SUBJECT: Chicago Executive Airport
Wheeling/Prospect Heights, Illinois
Cook County
Illinois Project Number: PWK-4407
SBG Project Number: 3-17-SBGP-XX
Contract No. PA057
Item No. 7A, August 1, 2014 Letting
Addendum A

NOTICE TO PROSPECTIVE BIDDERS

Revisions based on utility information and reviews for watermain and telecommunications.

CONSTRUCT ENGINEERED MATERIALS ARRESTING SYSTEM (EMAS) PHASE 3A - RUNWAY 16 END (34 DEPARTURE END) INCLUDING RUNWAY 16/34 OFA/RSA IMPROVEMENTS AND SITEWORK

Plan Sheet 10 of 31, **Existing Conditions – Proposed Removals:**

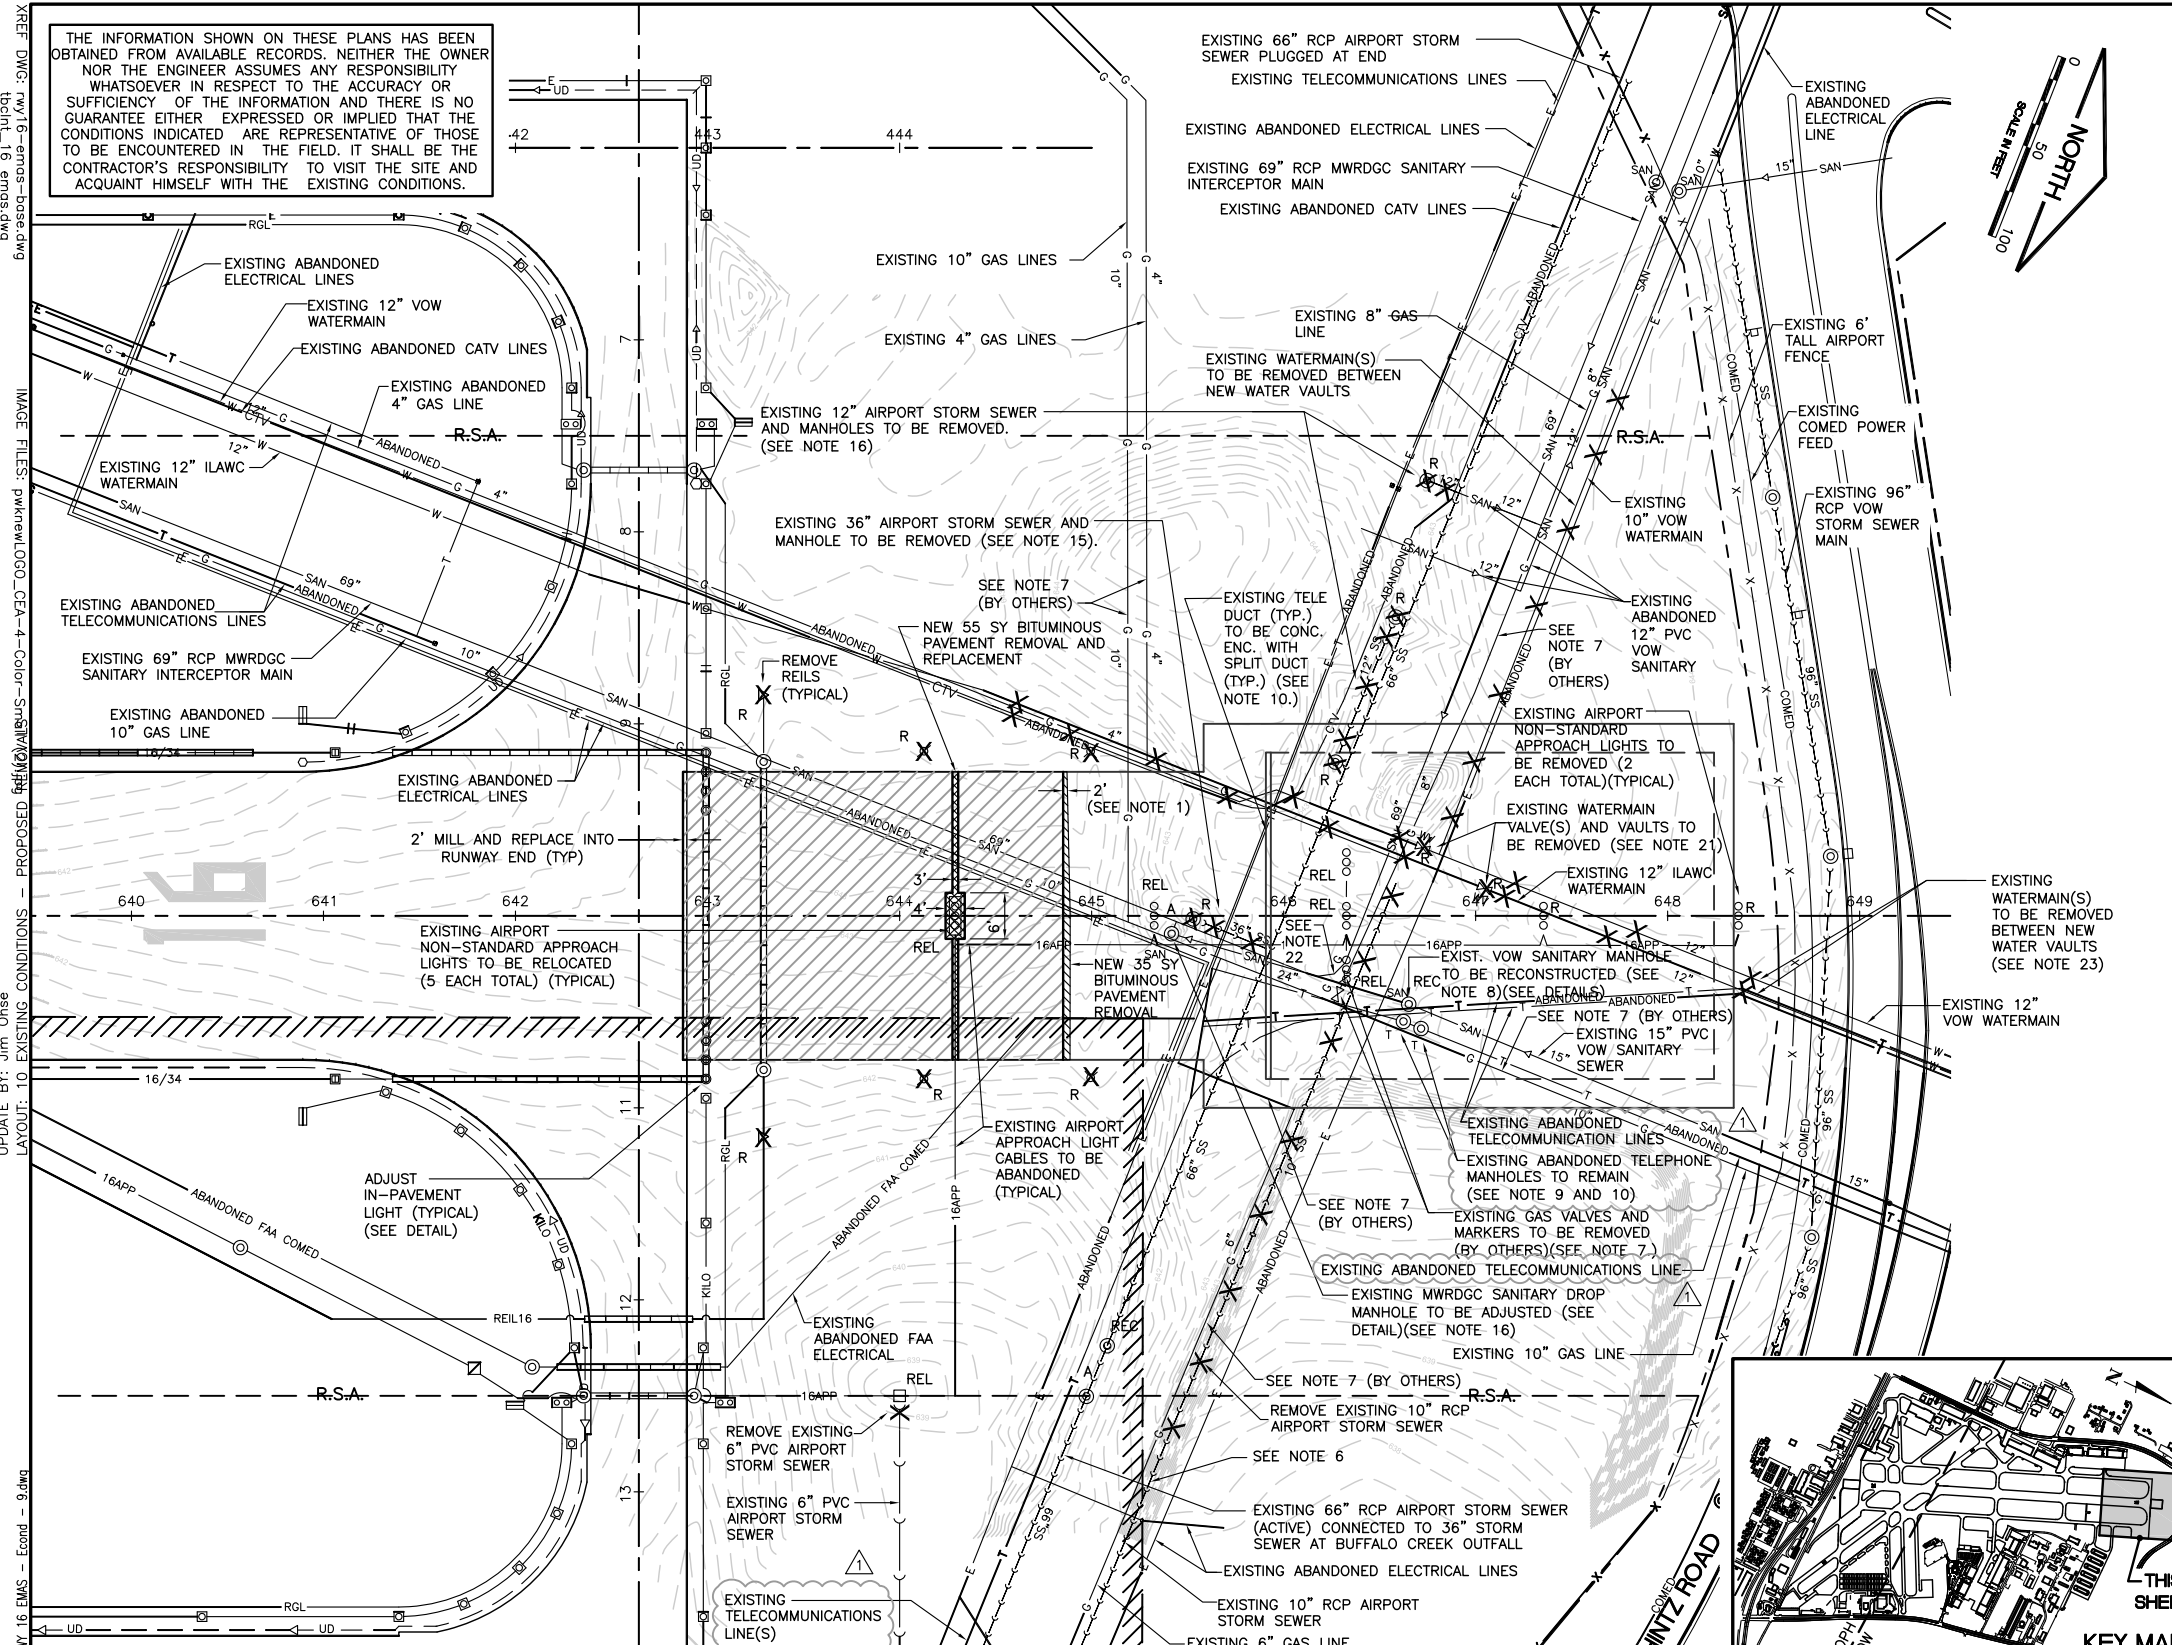
Revised information for existing utilities.

Plan Sheet 14 of 31, **Drainage and Utility Plan:**

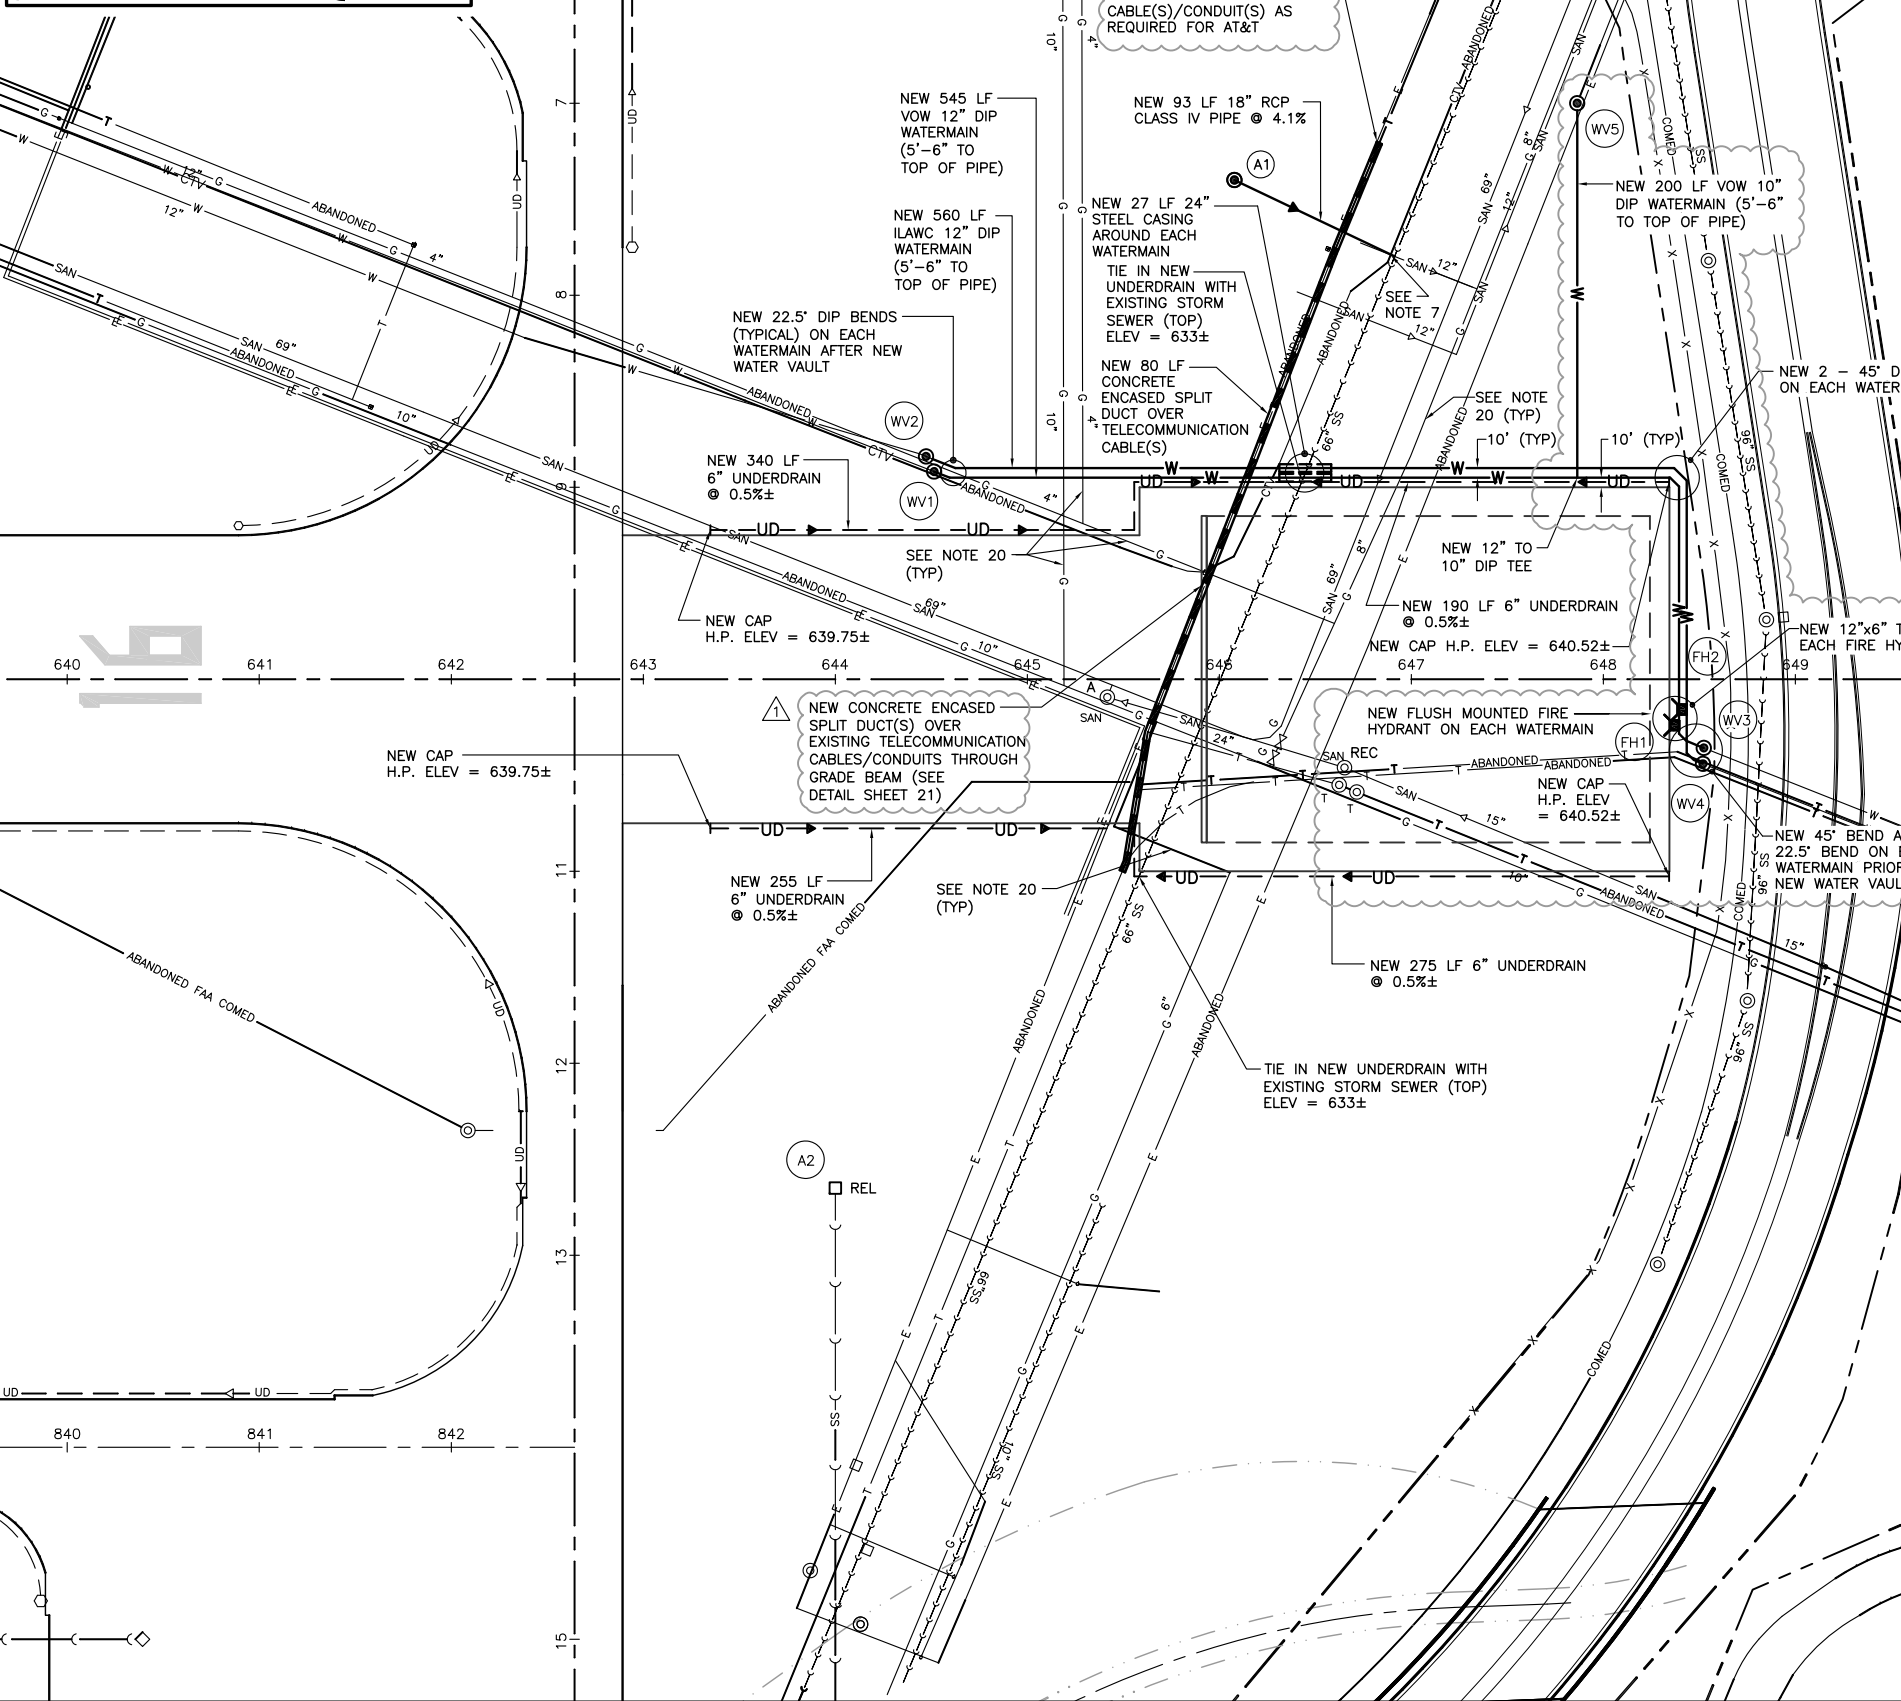
Revised watermain plan, layout and information.

Revised telecommunications protection and information.

Plan Sheet 15 of 31, **Drainage and Utility Profiles and Schedules:**

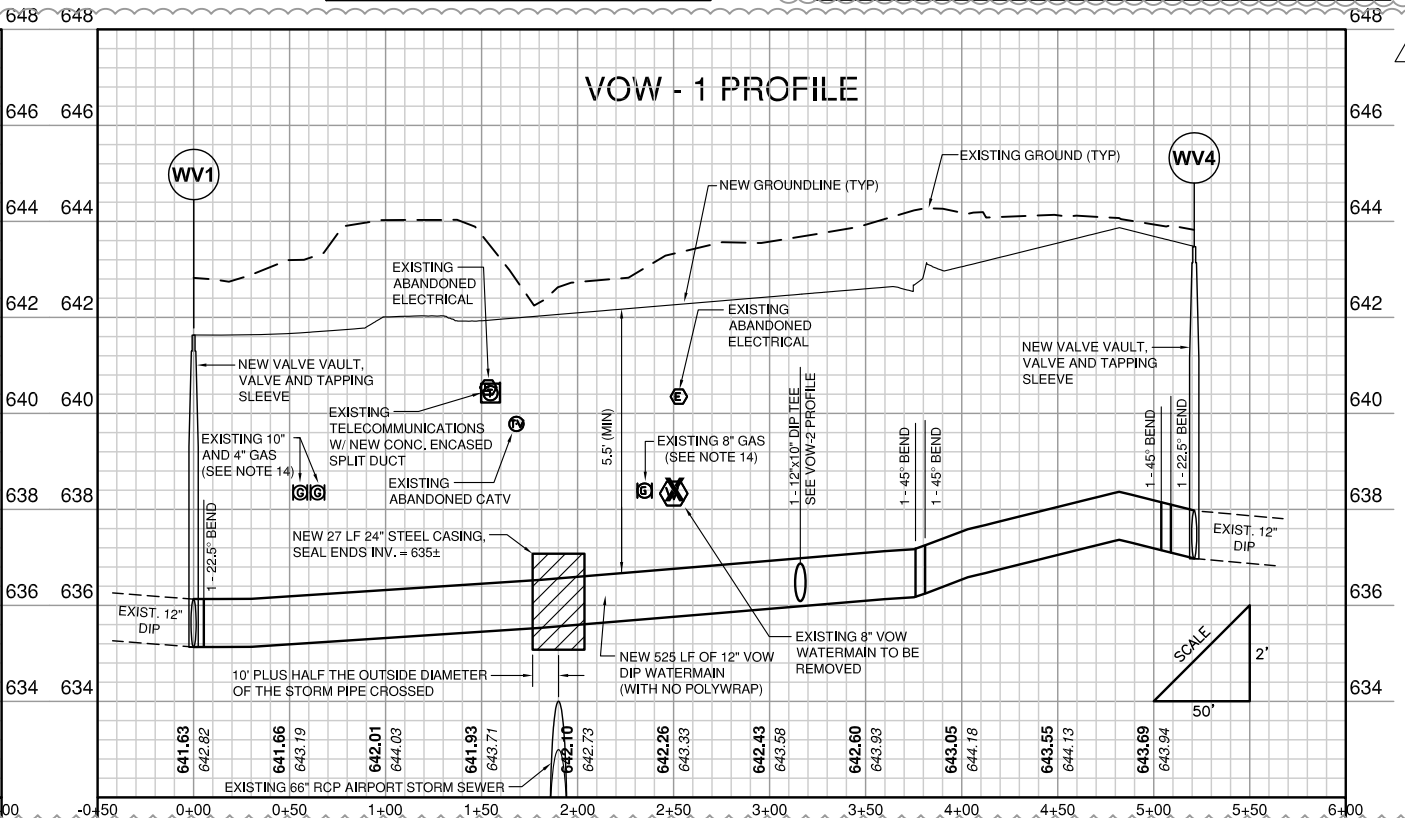
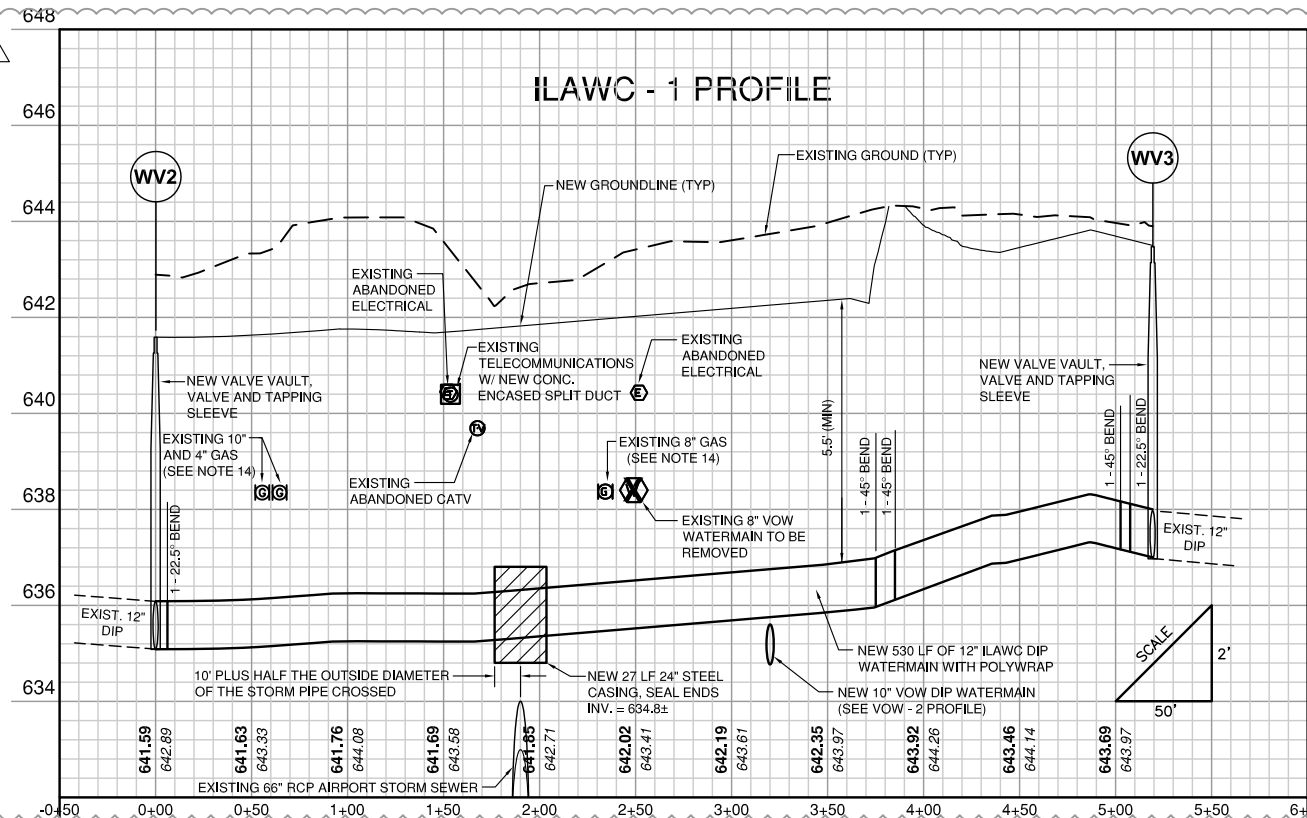
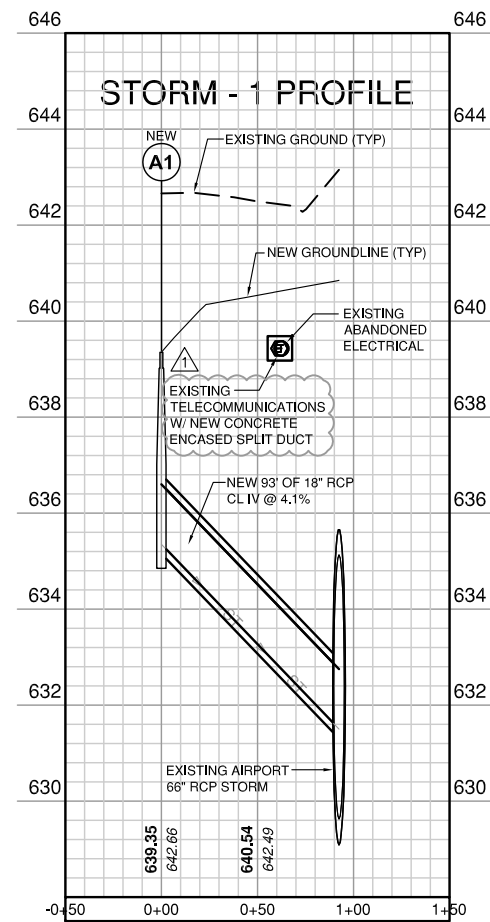
Revised watermain profiles, layout and information.

Revised Utility schedule.

Plan Sheet 17 of 31, **Drainage and Utility Details – Sheet 2:**

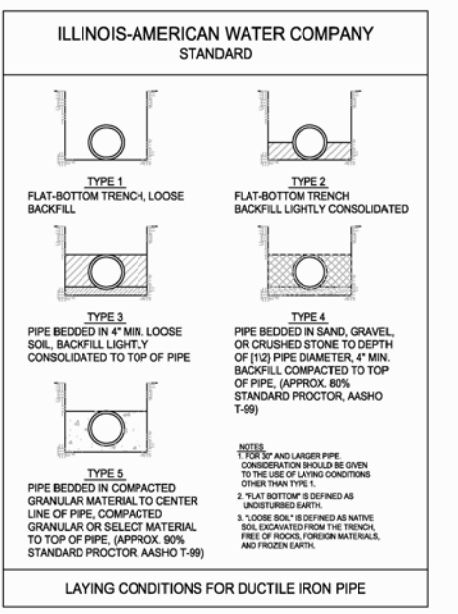
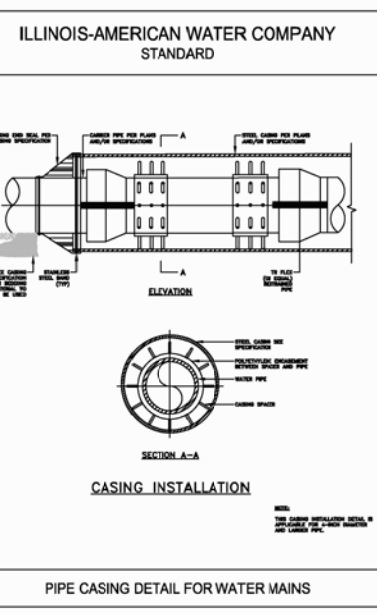
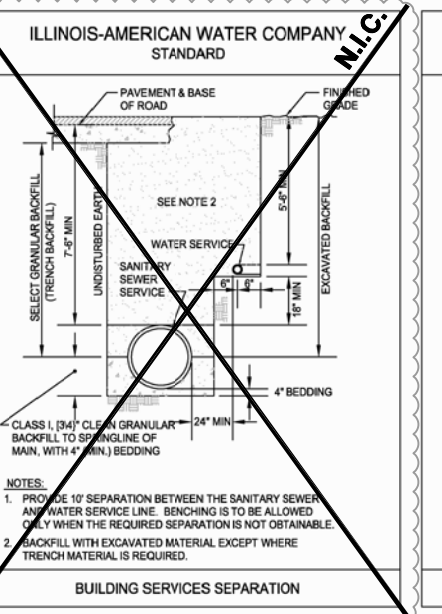
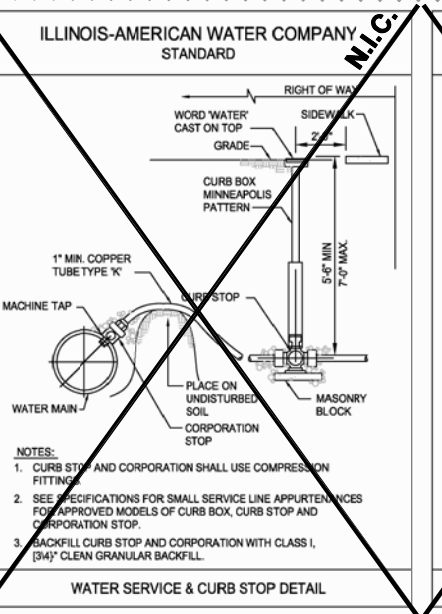
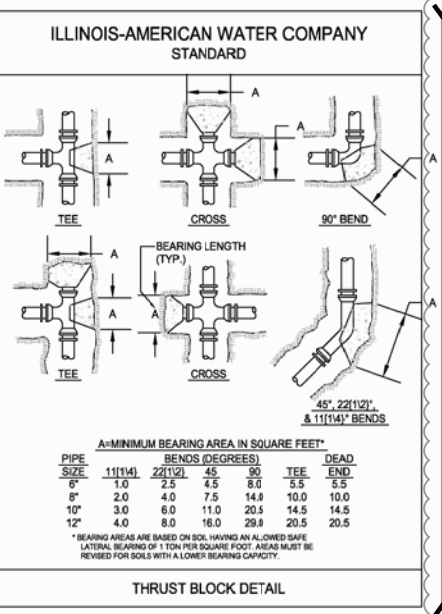
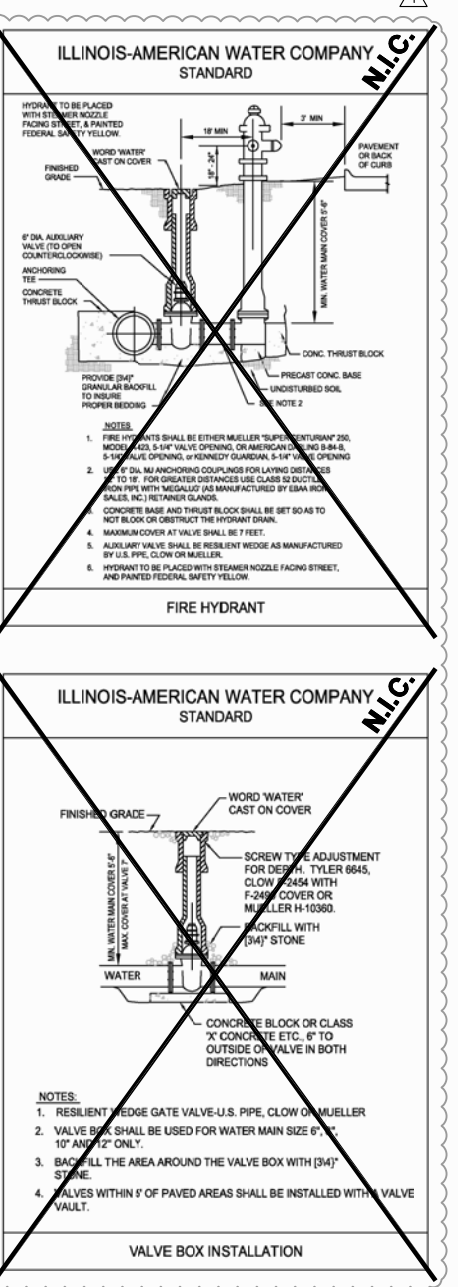
Revised and added details.
